## Flying Horse North – Phase 2 PUD Parcels 1-6 Preliminary Drainage Report

January 2024

PCD File No. PUD-SP234

Figure 1: Site Map

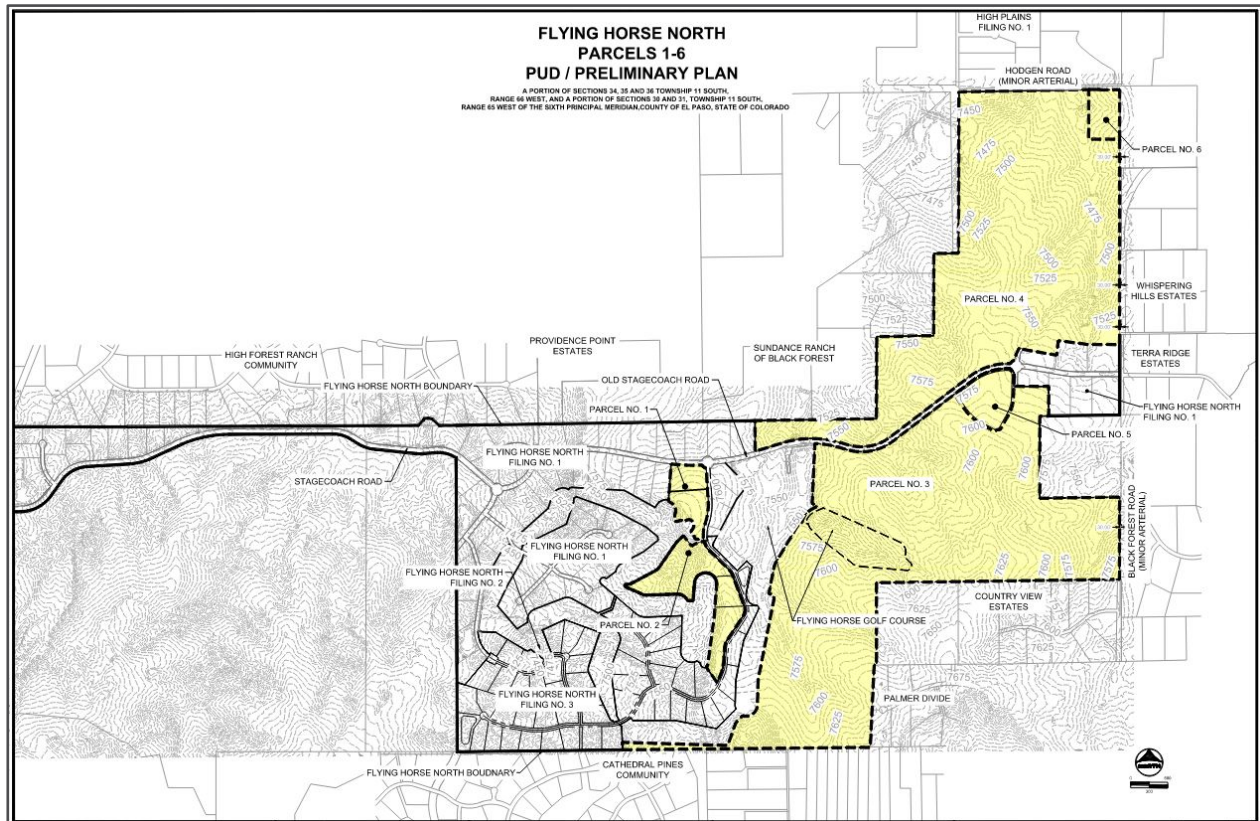
**Review C2: Unresolved. Please address the comment because a portion of site is within the floodplain.**

NO DETENTION AREAS  
 DETENTION EXCLUSION EXHIBIT

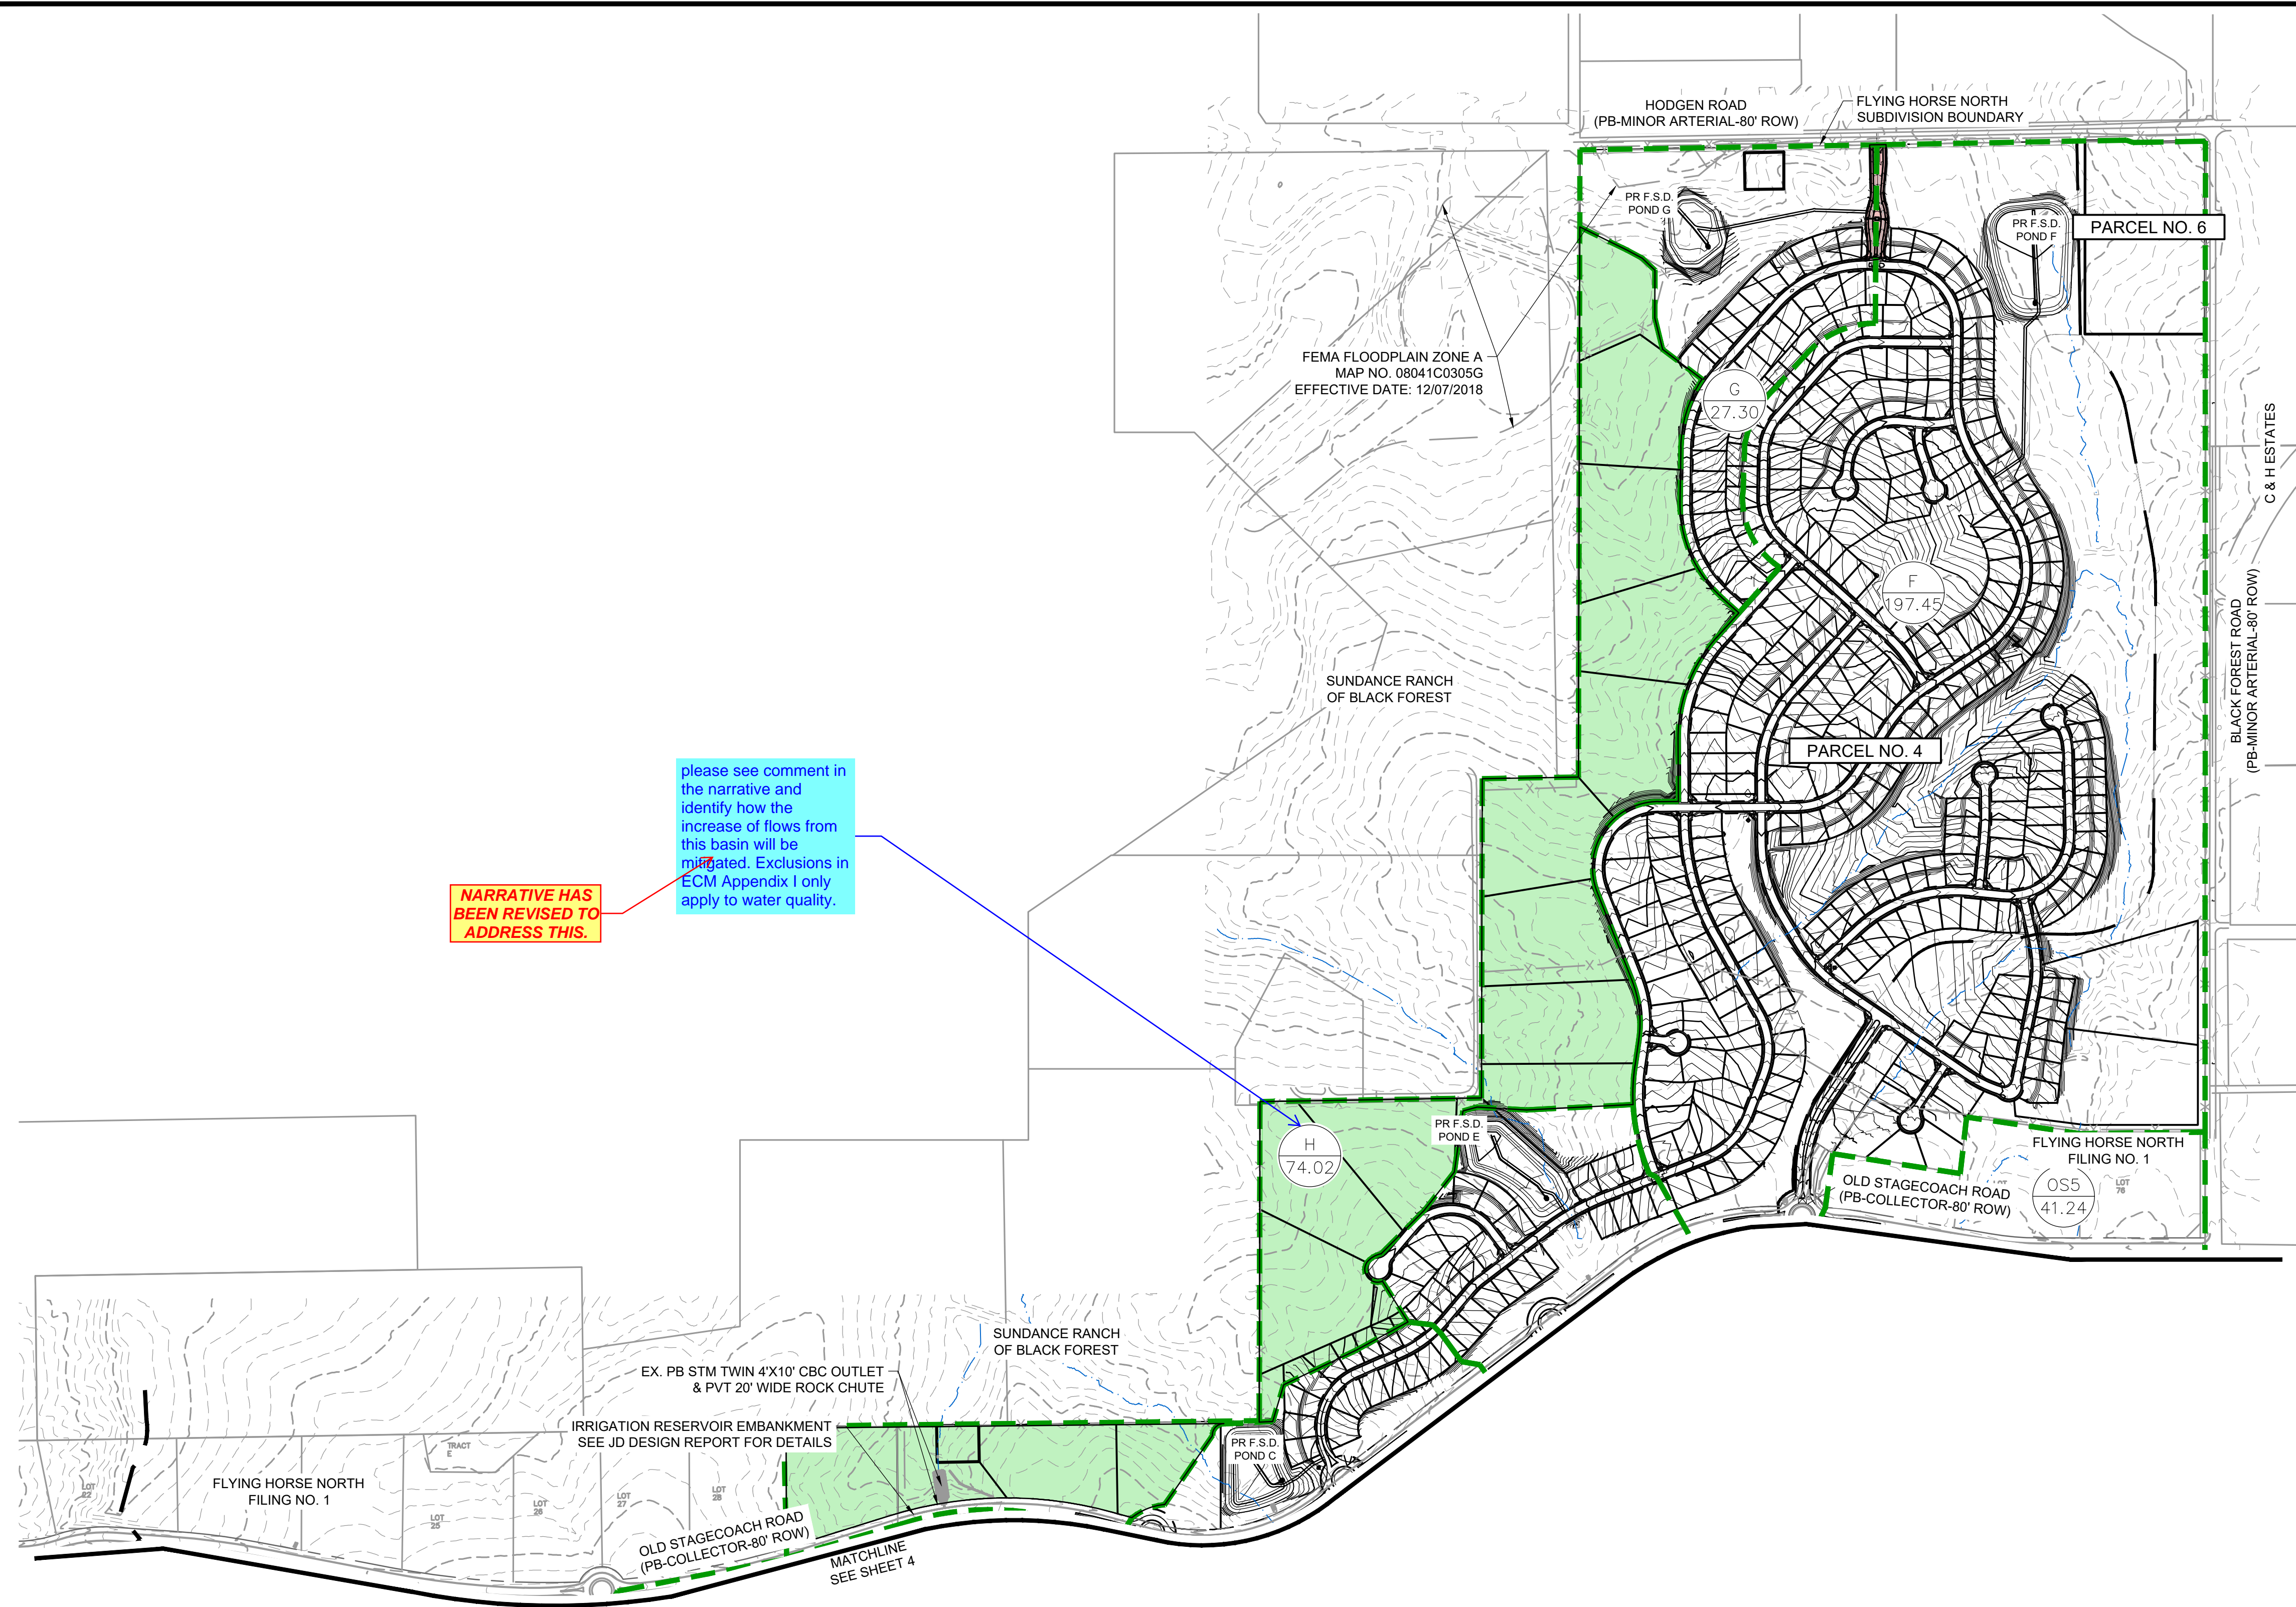
please see comment in the narrative and identify how the increase of flows from this basin will be mitigated. Exclusions in ECM Appendix I only apply to water quality.

**NARRATIVE HAS BEEN REVISED TO ADDRESS THIS.**
